6. AUTHOR(S) LCDR F. D. Holcombe, MSC, USN and LT S. C. Webb, MSC, USNR					
7. PERFORMING ORGANIZATION NAME(S) AND ADDRESS(ES) Naval Biodynamics Laboratory P. O. Box 29407 New Orleans, LA 70189-0407				8. PERFORMING ORGANIZATION REPORT NUMBER NBDL-91R003

U. S. Coast Guard 47-ft Motor Lifeboat.

HUMAN FACTORS ASSESSMENT OF USCG 47-FT MOTOR LIFE BOAT

I: Preliminary Evaluation of Ergonomic and Safety Deficiencies

Figure I.2. Appropriate and inappropriate ways of descending a ladder.

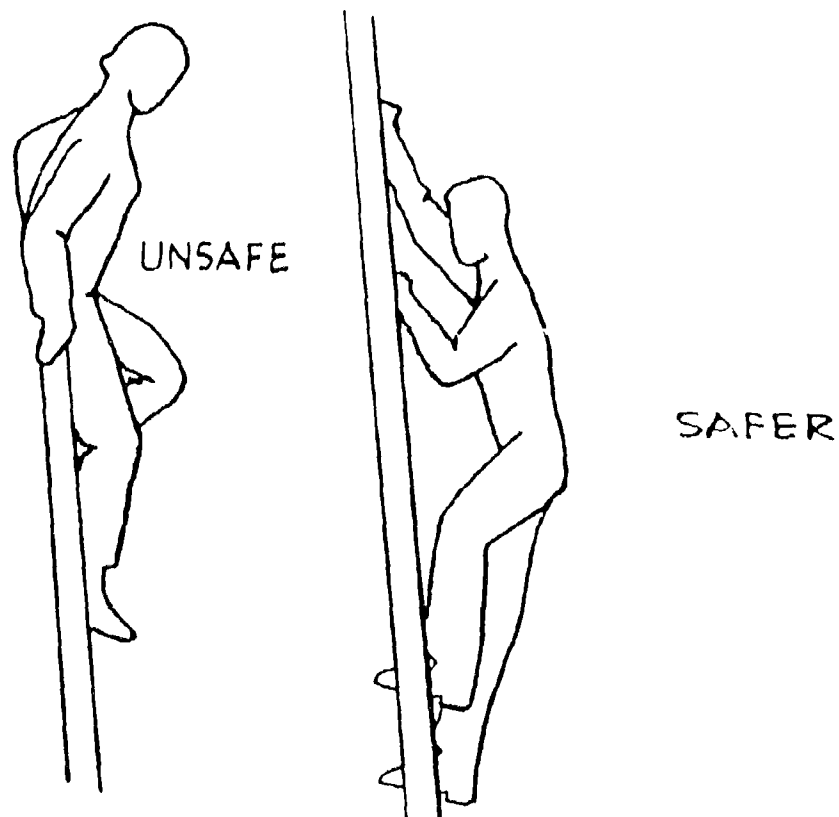
Caution: Crewmembers should be discouraged from facing away from the ladder while descending (see Figure I.2). A potential for injury exists, both by falling from the ladder and by falling into the towing bit located on this aft deck.

Figure I.3. Watertight door with control wheel, extended handle, and dogs.

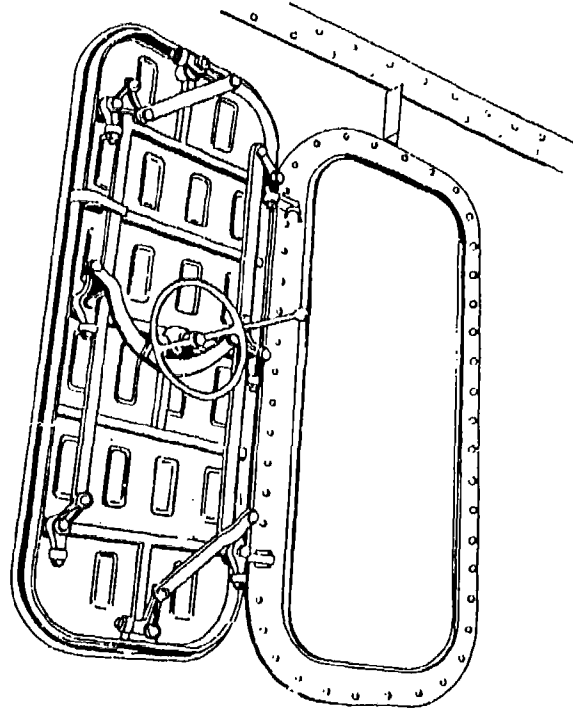
- Problem:**
- Potential for personal injury exists while crew pass through the door. Crew are required to hold the door with one hand, grab the handrail with the other, and walk up the ladder simultaneously. In rough seas crew will not be able to maintain positive control, thereby increasing the risk of injury.

- The door impedes the movement of the port OB chair.
 - The bolts of the door are exposed and present a hazard to the crew passing through the door. Crewmembers have reported minor injuries due to these bolts.

- Approach:**
- The door should be designed with a self-locking mechanism to secure the door in an open position. This mechanism is recommended for all doors.

- All doors are operated at once by the extended handle located on the control wheel of the watertight door. The handle will provide positive control for the crew (see Figure I.3).

Figure II.1a. Current starboard steering station on open bridge.

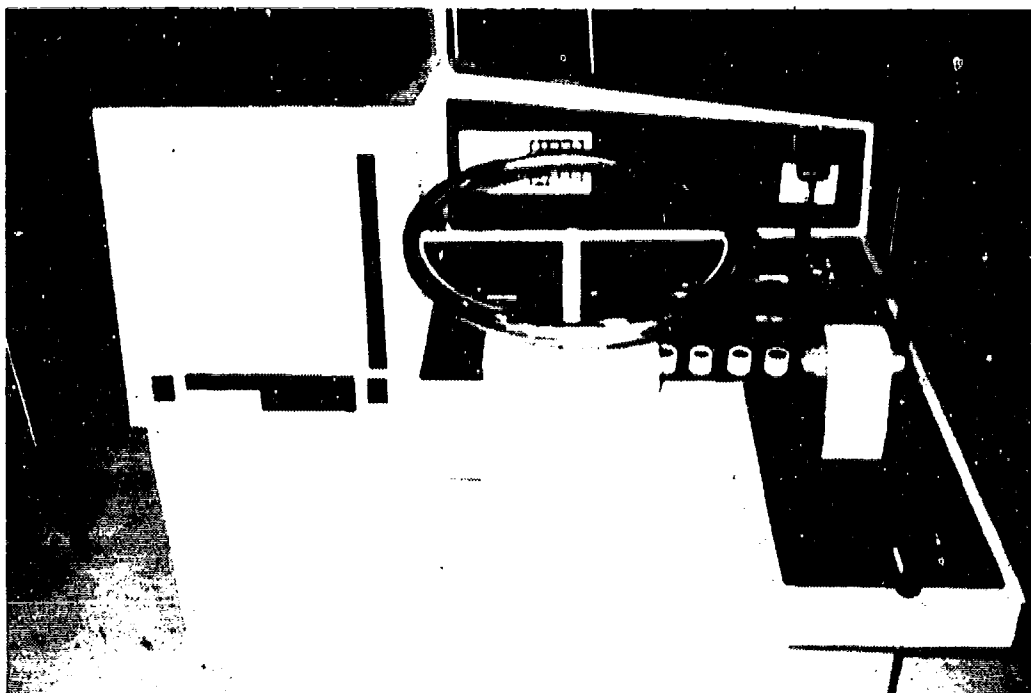
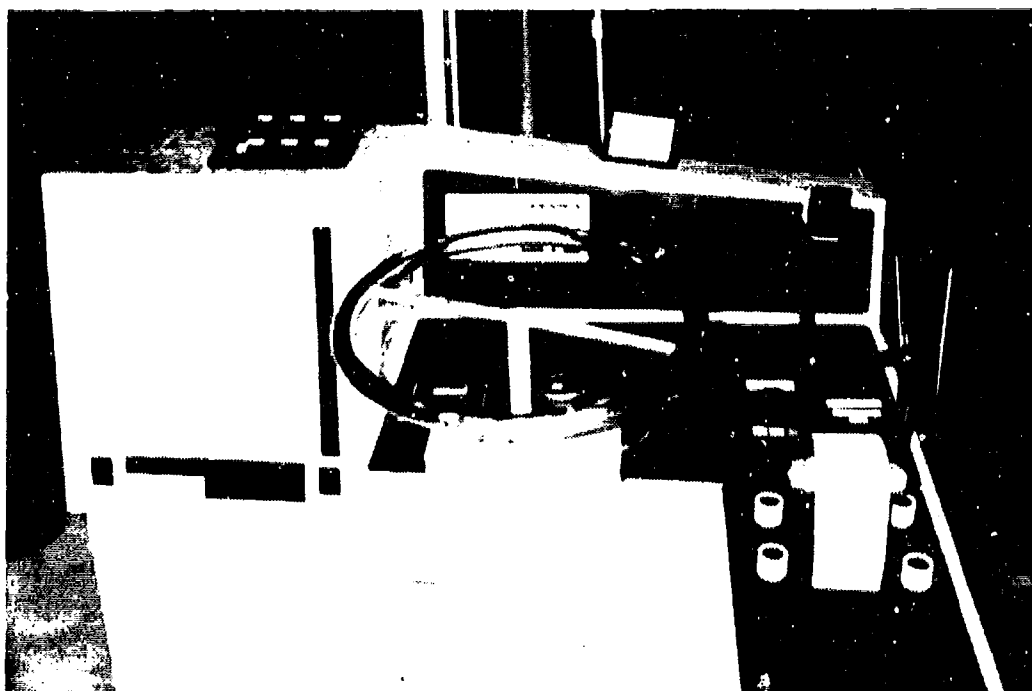
Figure II.1a represents the current layout of the starboard console on the open bridge. The layout of the starboard console (primary steering station) provides both a steering wheel and a backup jog lever steering control.

- All controls and displays viewed and controlled by the operator are not clearly visible from the normal operating position (seated). In

- In place of two microphones, use a single microphone and selector switch to reduce the viewing obstruction to the control and displays. The switch should be located in close proximity to the microphone (see Figure II.1b).

Figure II.11. Wide angle view of enclosed bridge.

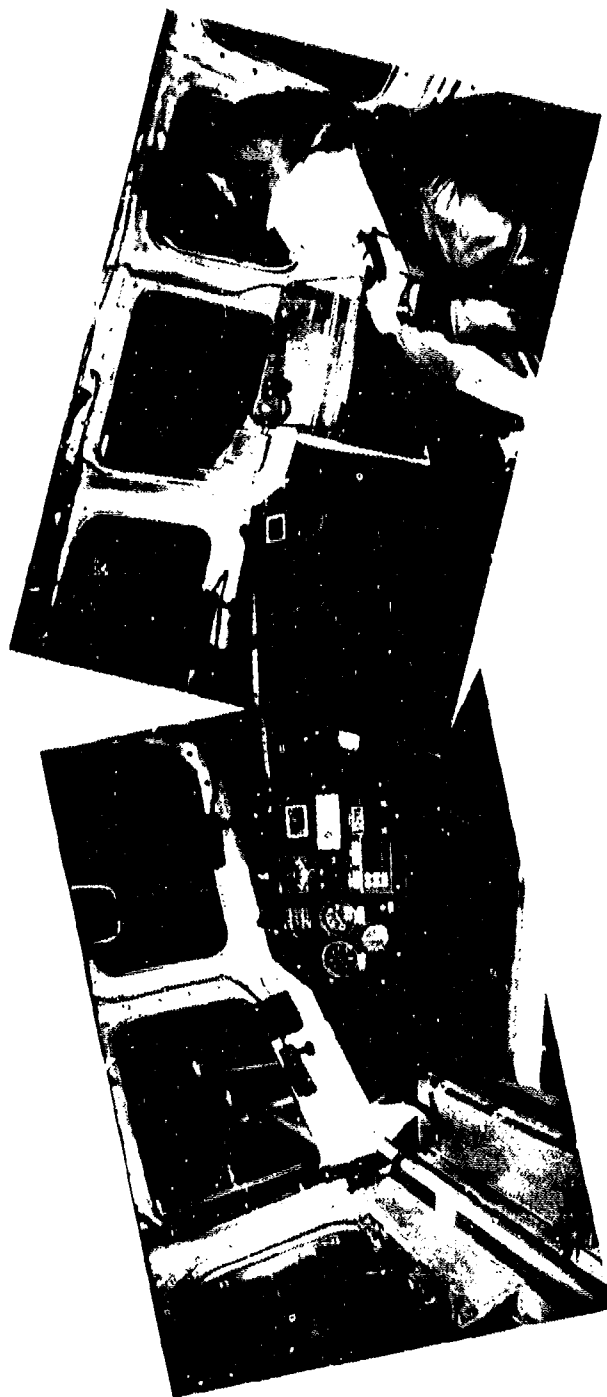
The appearance of the steering stations seems to indicate that the existing layout of controls and displays was based primarily on space considerations, placing equipment where it would fit (see Figure II.11). A more organized arrangement is possible. However, the current layout due to the constraints of the boat may not follow optimal human factors engineering fundamental guidelines, but should be adequate.

Figure II.15. Aft window of the enclosed bridge battle lantern and hydraulic fluid reservoir.

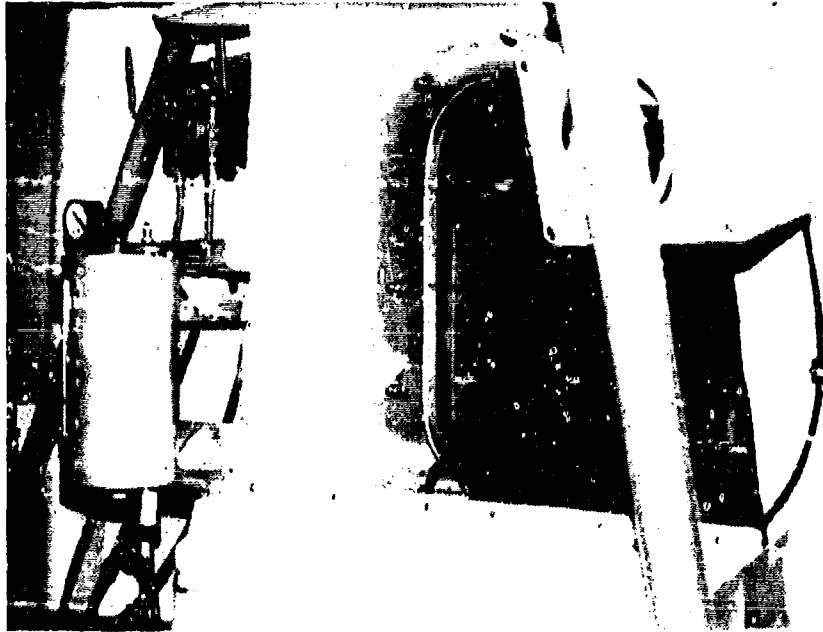
- Hydraulic fluid reservoir: This instrument is located on the aft bulkhead of the enclosed bridge, starboard of the aft window (see Figure II.15).
- Problem:**

Figure II.18a. Radar plotter screen.

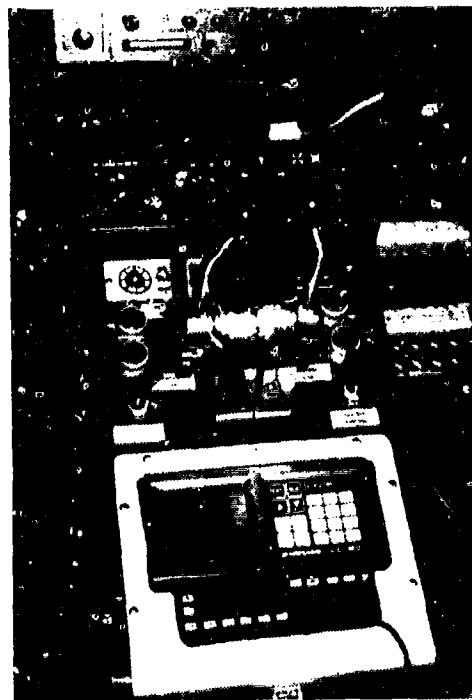
- Problem:**
- Radar plotter screen: The radar plotter is located between the port and starboard dashboards. The radar plotter is visible and accessible to both operator positions (see Figure II.18).

Figure II.20. Wet compass and window wiper controls.

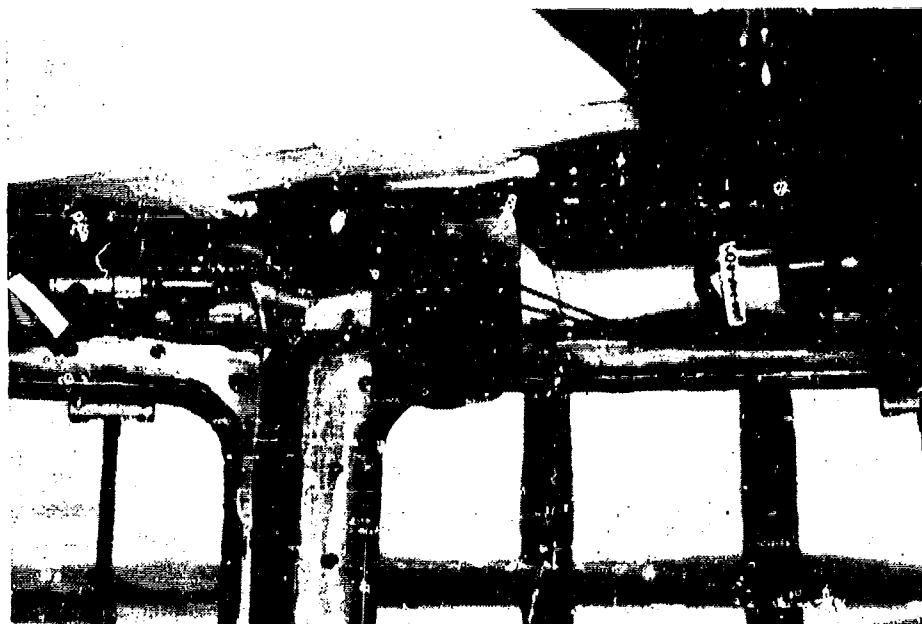
- Arrange the gauges in a similar manner in both open and enclosed bridges (see Figures II.5 and II.12).
 - Wet compass in the enclosed bridge: This compass is attached to the overhead above the port operator's position (see Figure II.20). Normally, to steer a heading, one lines up the compass lubber line with the desired course degree heading of the compass. The helmsman and lubber line are normally in parallel alignment with the boat's longitudinal axis.

- It is recommended that the wet compass be retained in the enclosed bridge and located on the dashboard in line with, or directly above, the main steering position.

Figure II.22. Window/heaters junction box in enclosed bridge overhead.

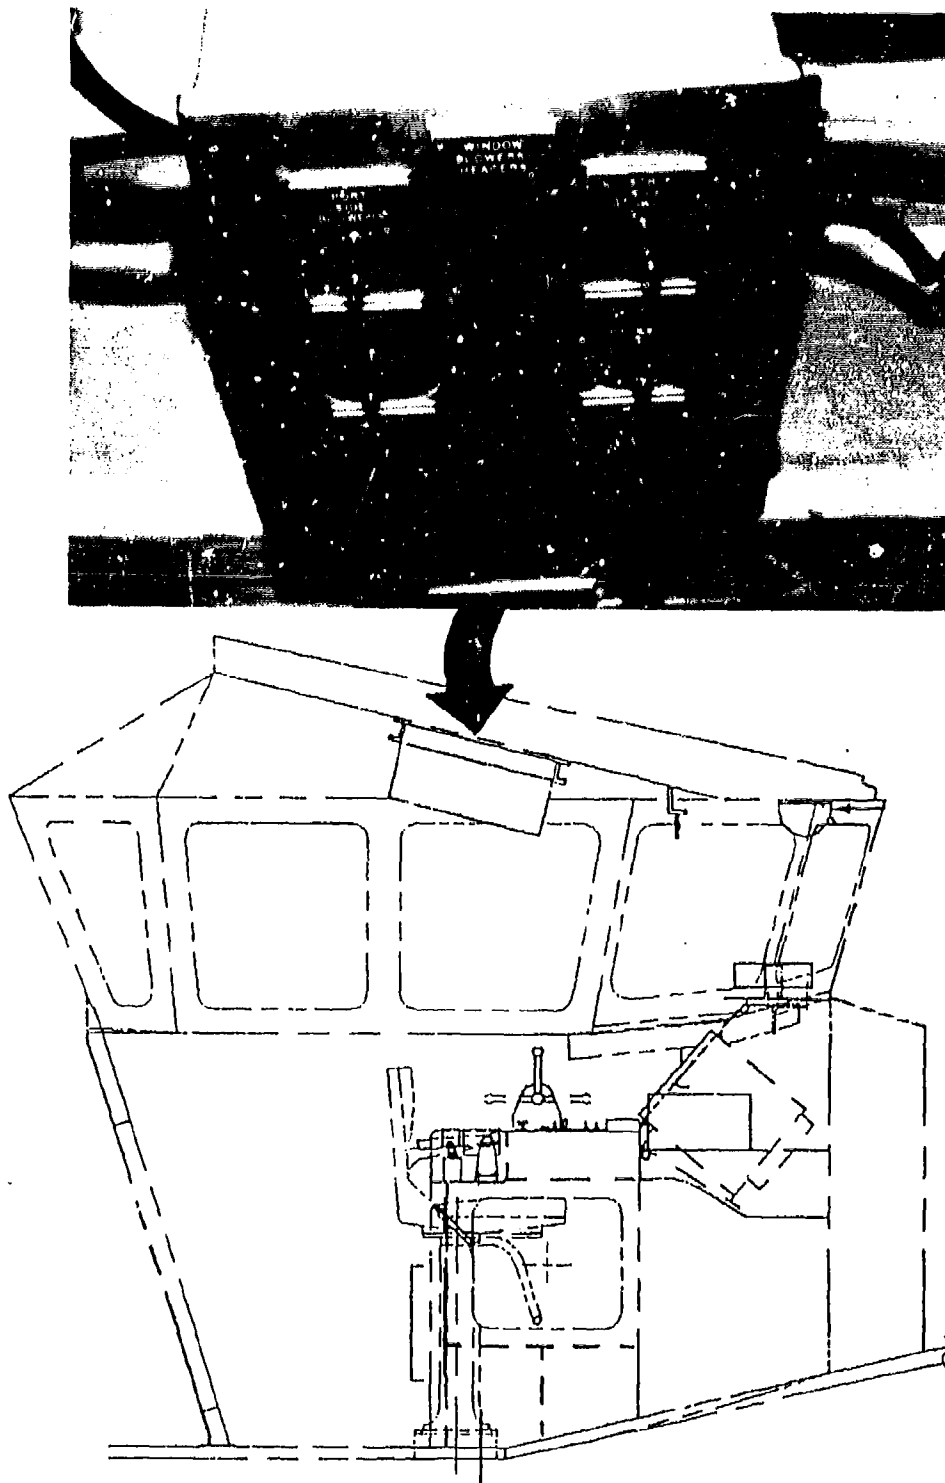
The window blower/heater switch panel is mounted on the overhead at the centerline and between the two forward seats (see Figure II.22). The window washer button is located on the dashboard in front of the portside chair. The window wiper control panel is located directly aft of the radar plotter keyboard.
